**City of Kingston**  
**Report to Heritage Properties Committee**  
**Report Number HP-24-012**

**To:** Chair and Members of the Heritage Properties Committee  
**From:** Jennifer Campbell, Commissioner, Community Services  
**Resource Staff:** Kevin Gibbs, Director, Heritage Services  
**Date of Meeting:** February 21, 2024  
**Subject:** Application for Heritage Permit  
**Address:** 47 Wellington Street (P18-386)  
**File Number:** File Number: P18-096-2023

An application for alteration under Section 42 of the *Ontario Heritage Act* (P18-096-2023) has been submitted to support a total of 17 condominium units for the entire property by building a rear yard, four-storey flat-roofed addition with an associated service elevator that will attach to the existing schoolhouse. This application was deemed complete on January 4, 2024. The *Ontario Heritage Act* provides a maximum of 90 days for Council to render a decision on an application to alter a heritage building under Section 42(4). This timeframe will expire on April 3, 2024.

Project:	47 Wellington Street	Date:	2023-11-28
File Name:	17077_A020_ELEV	By:	
Client Project:		Drawing Number:

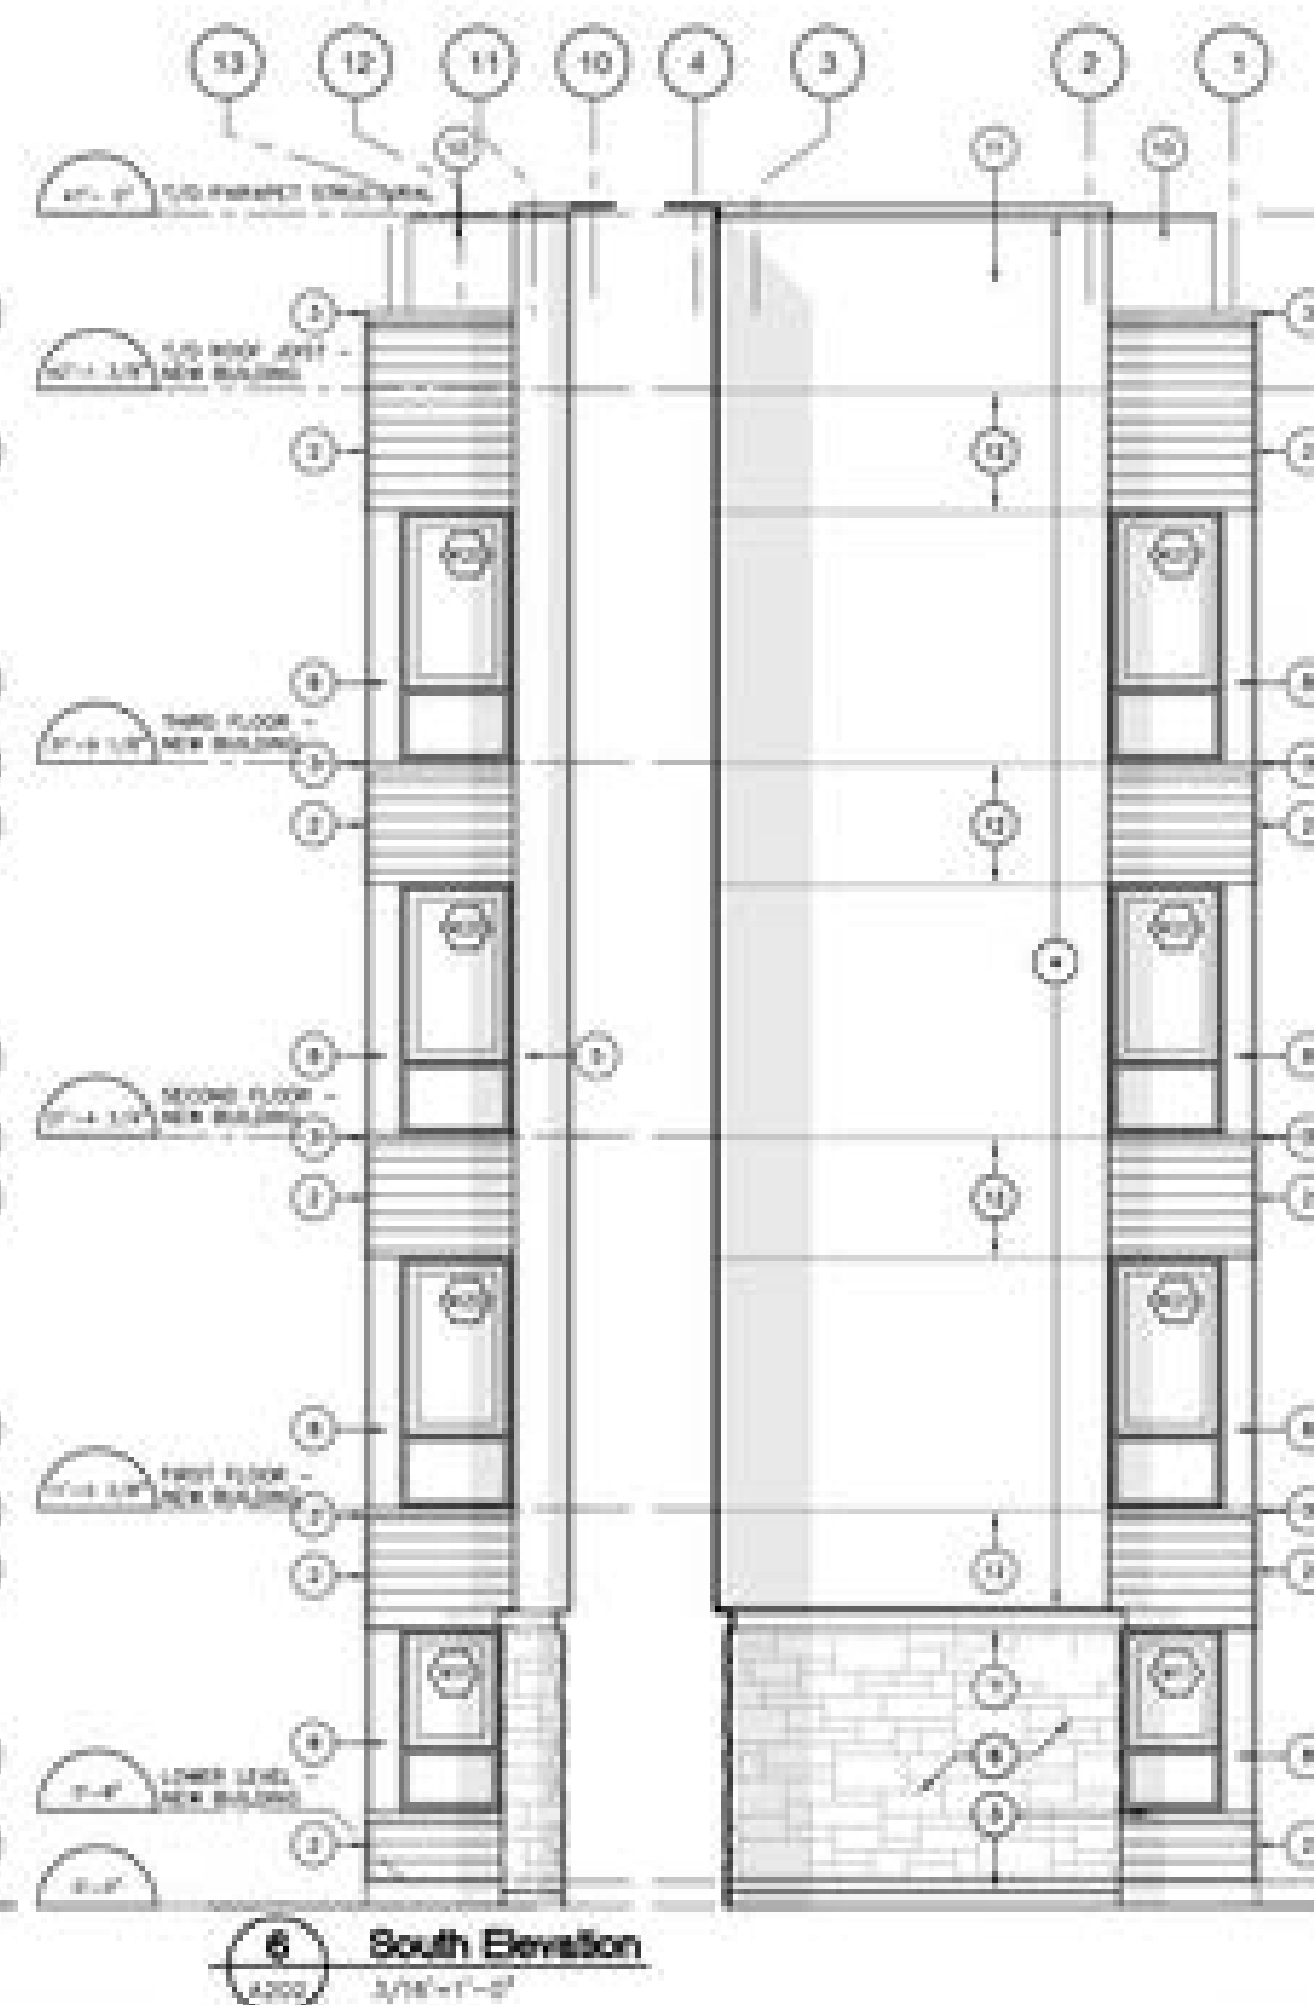
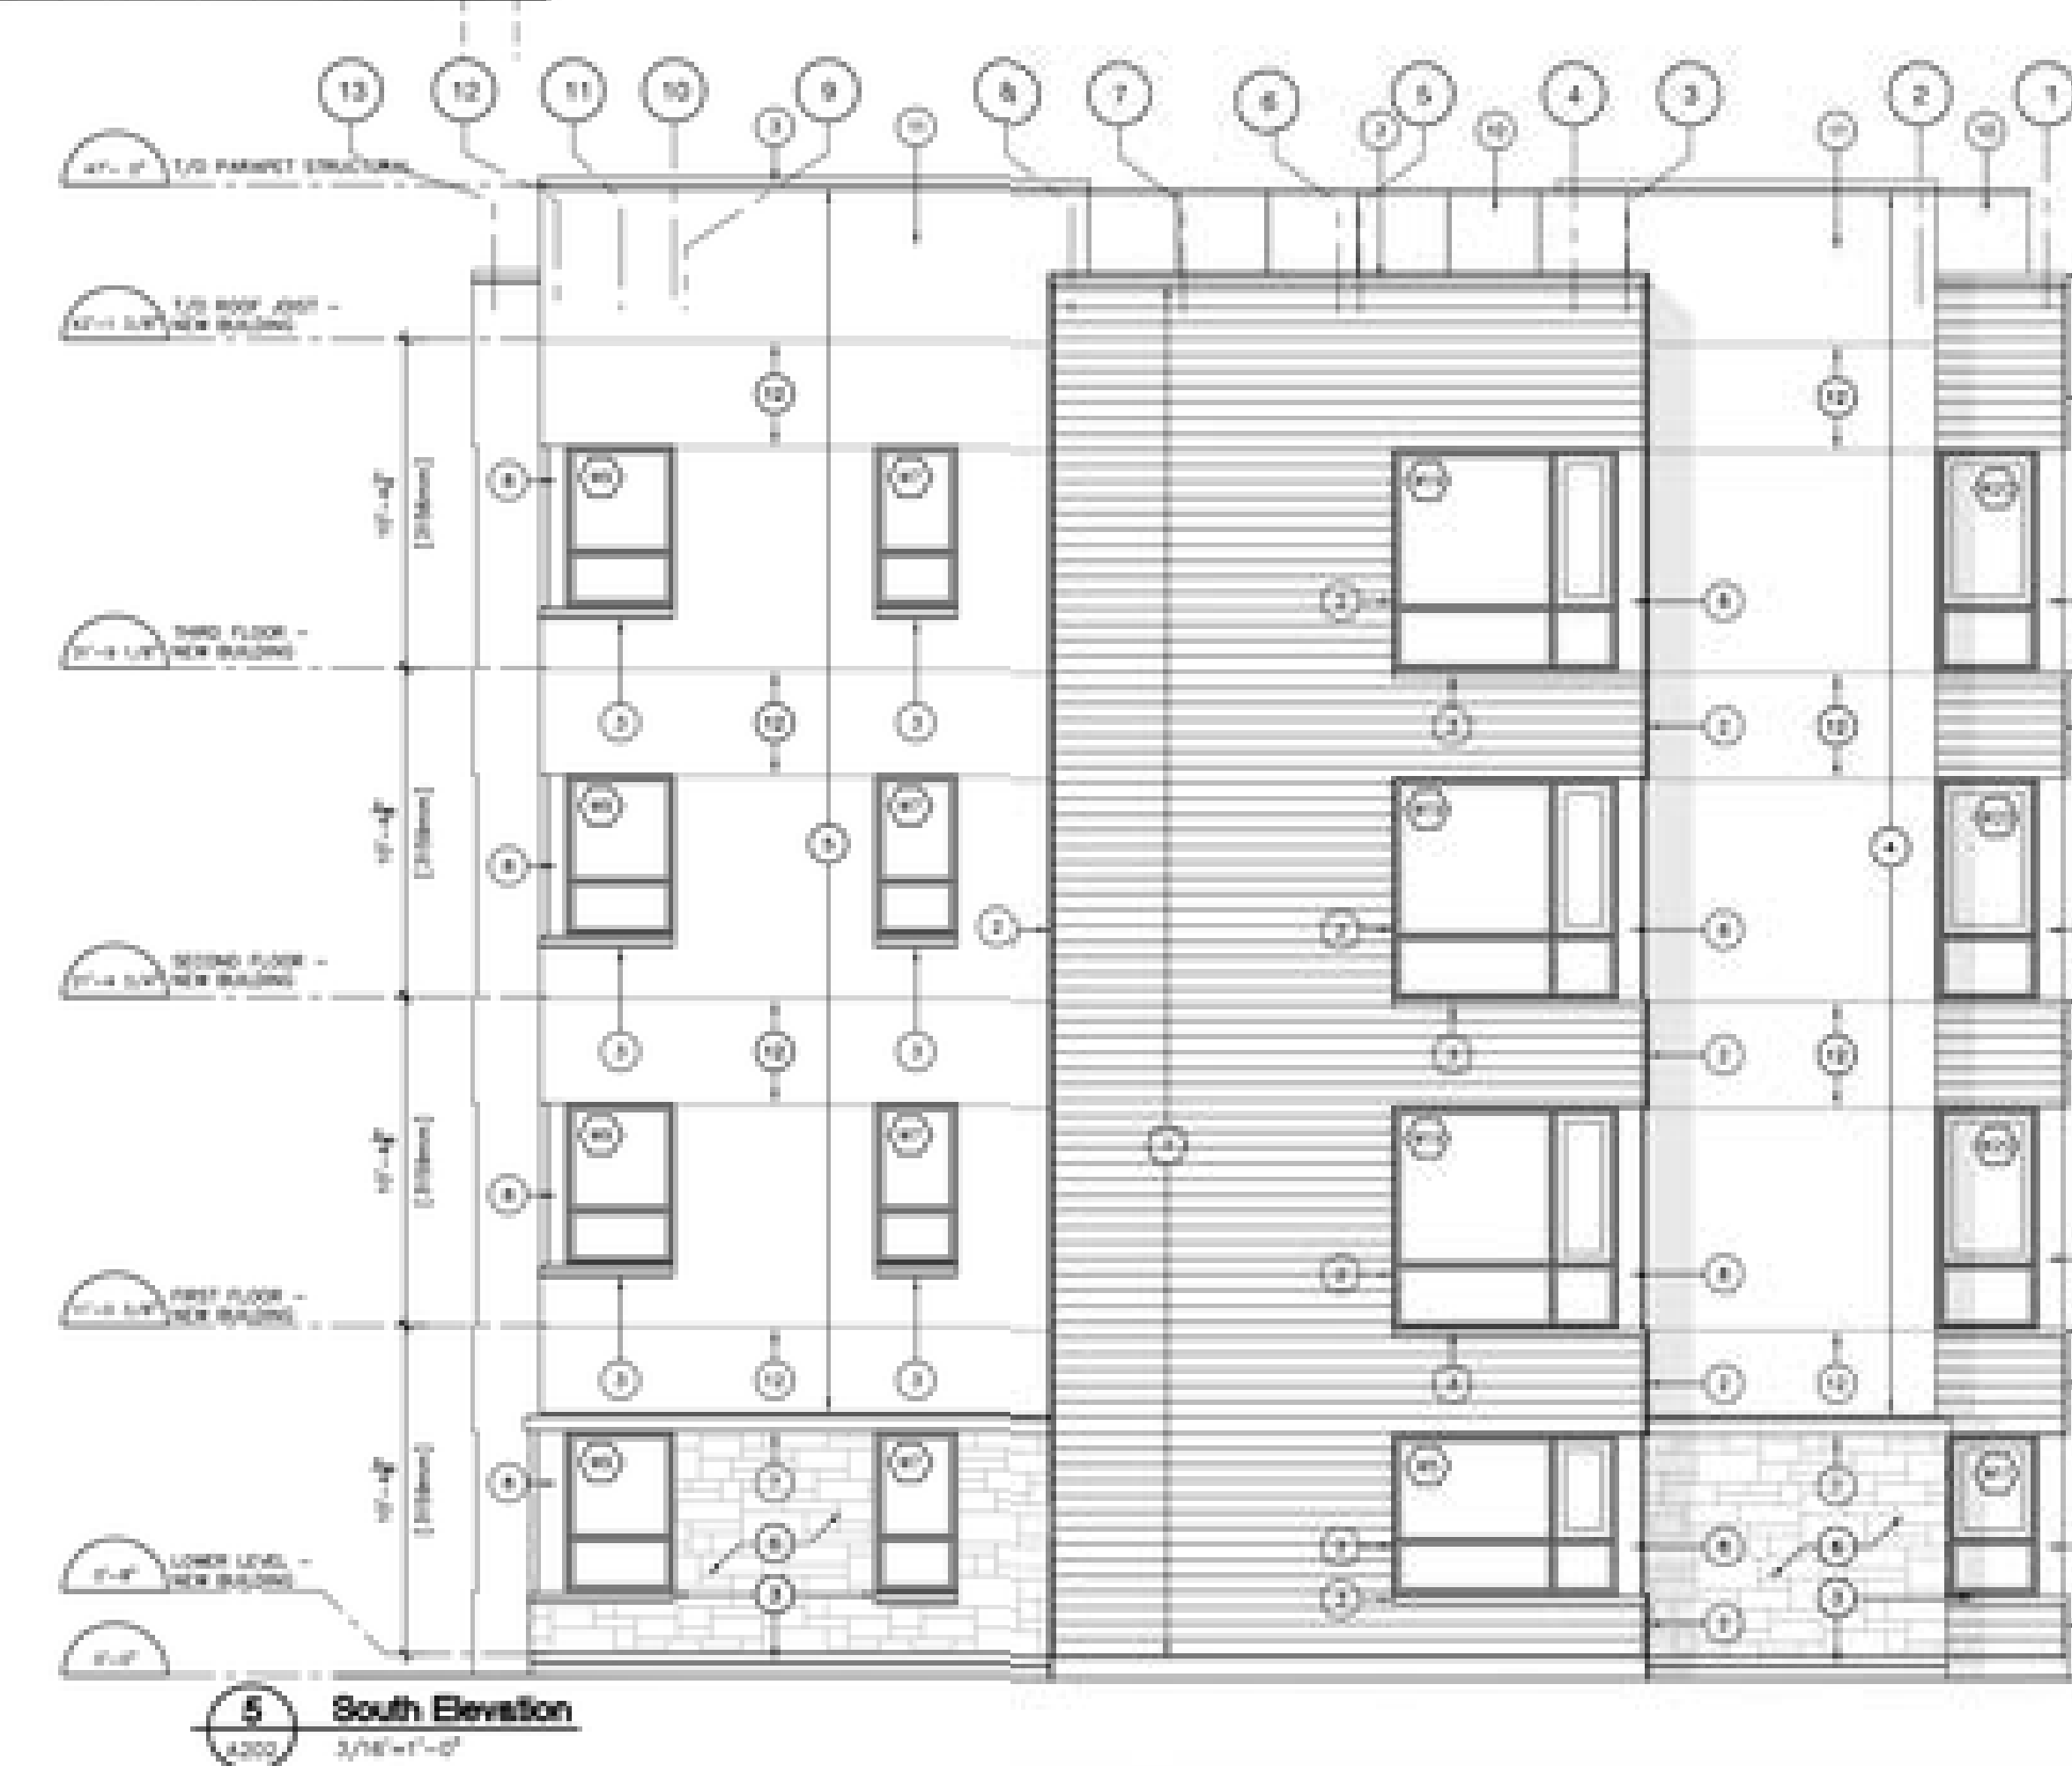
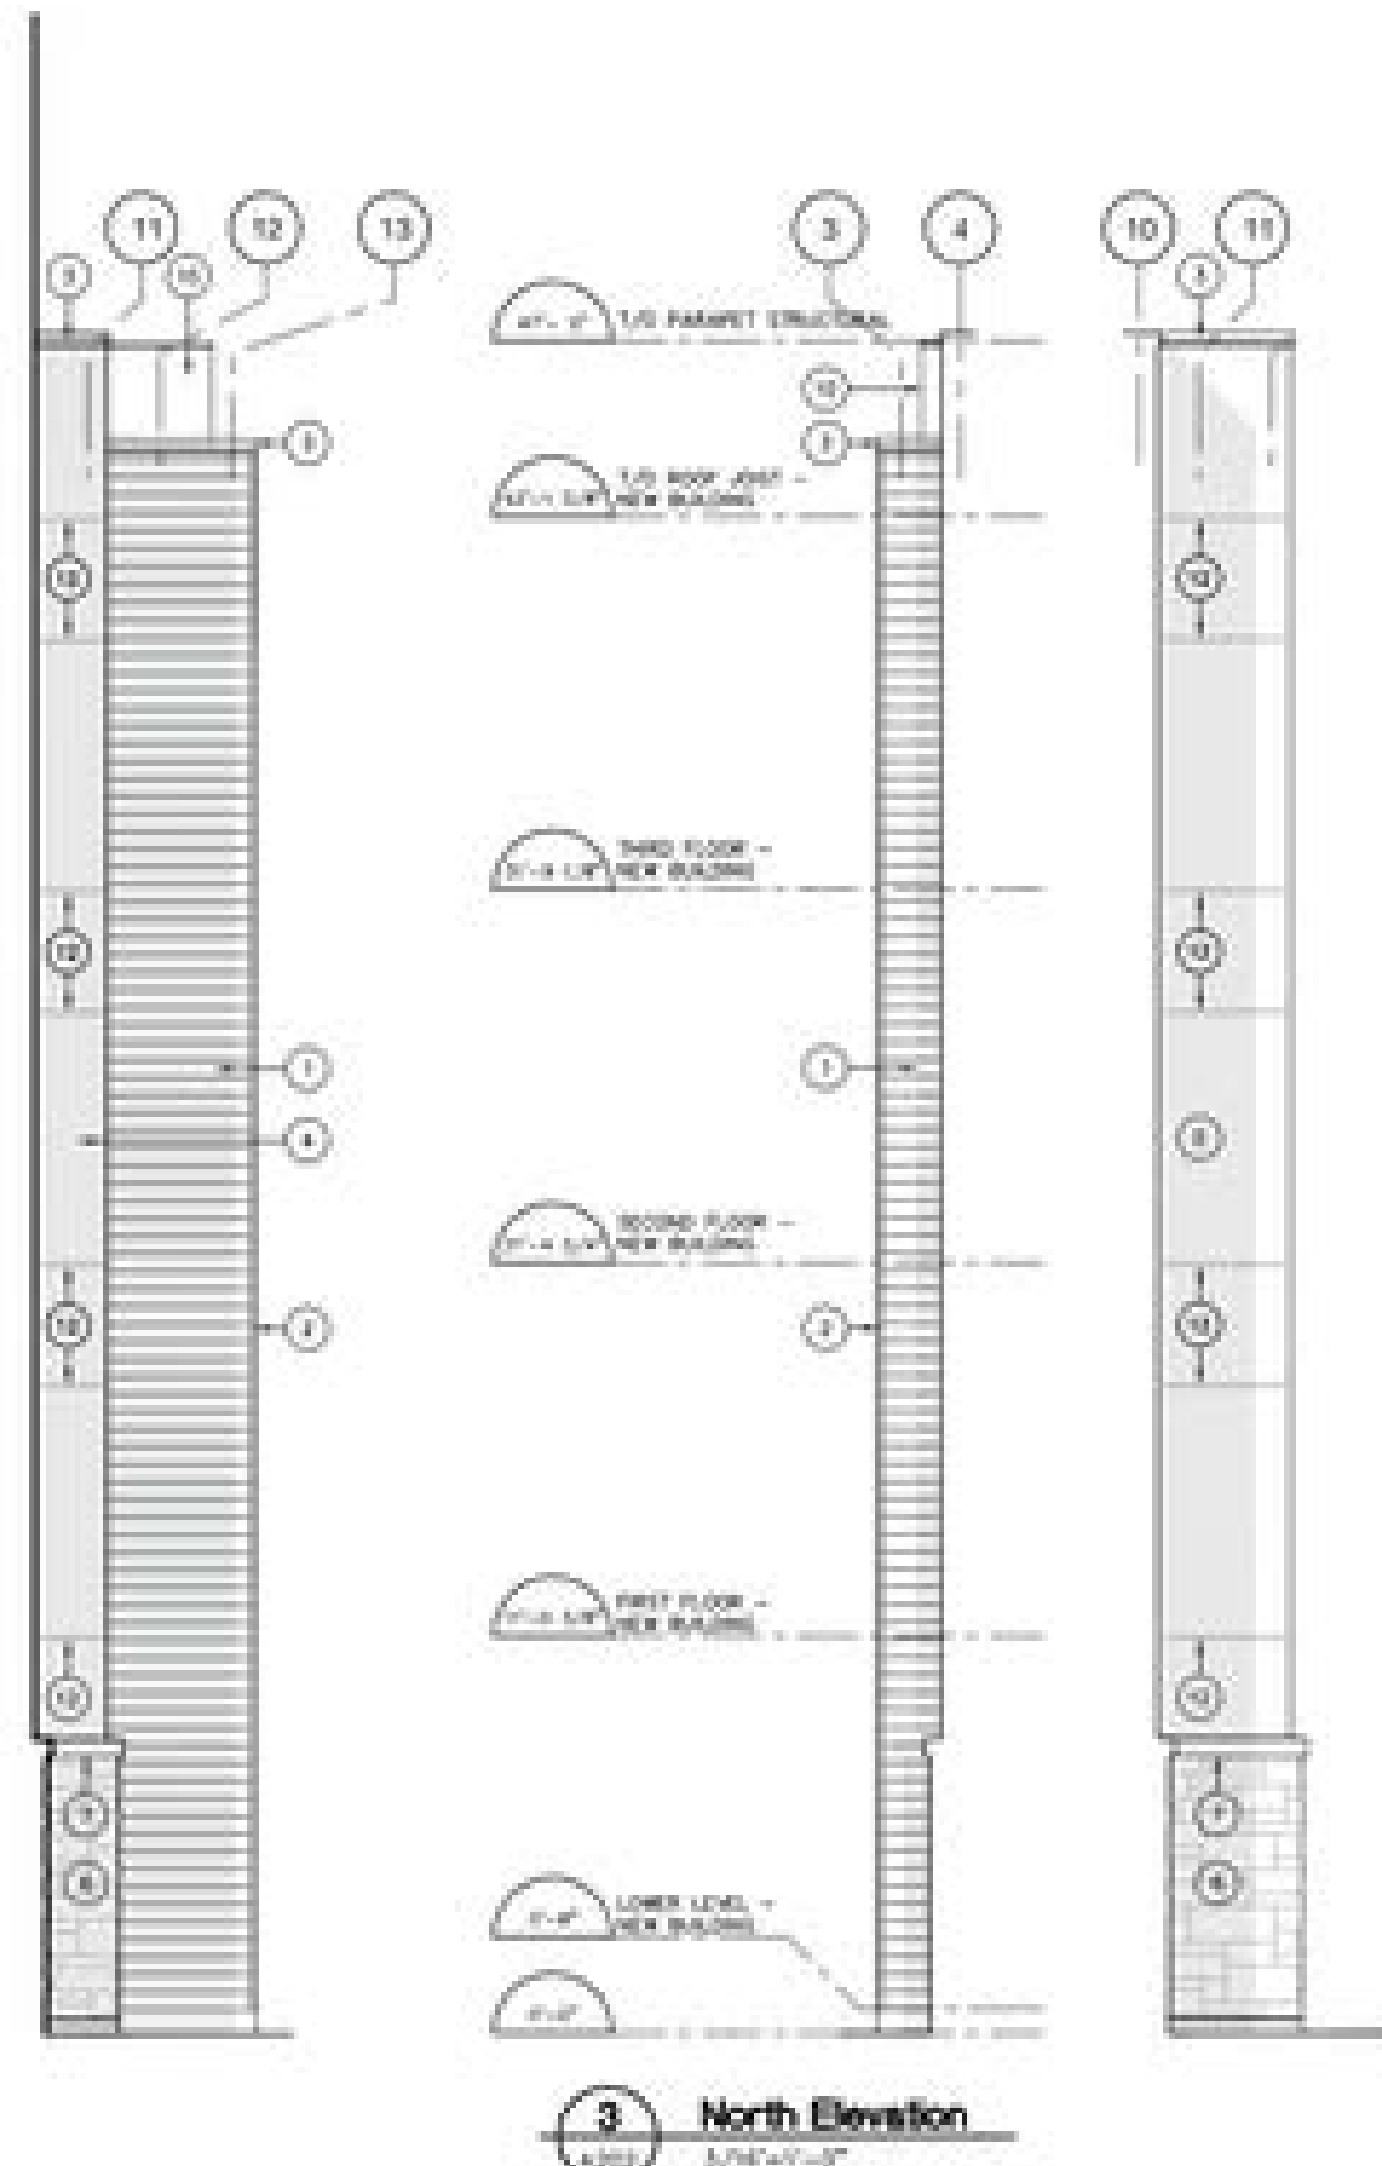
Height of elevator overrun reduced by 0.5-0.75 metres
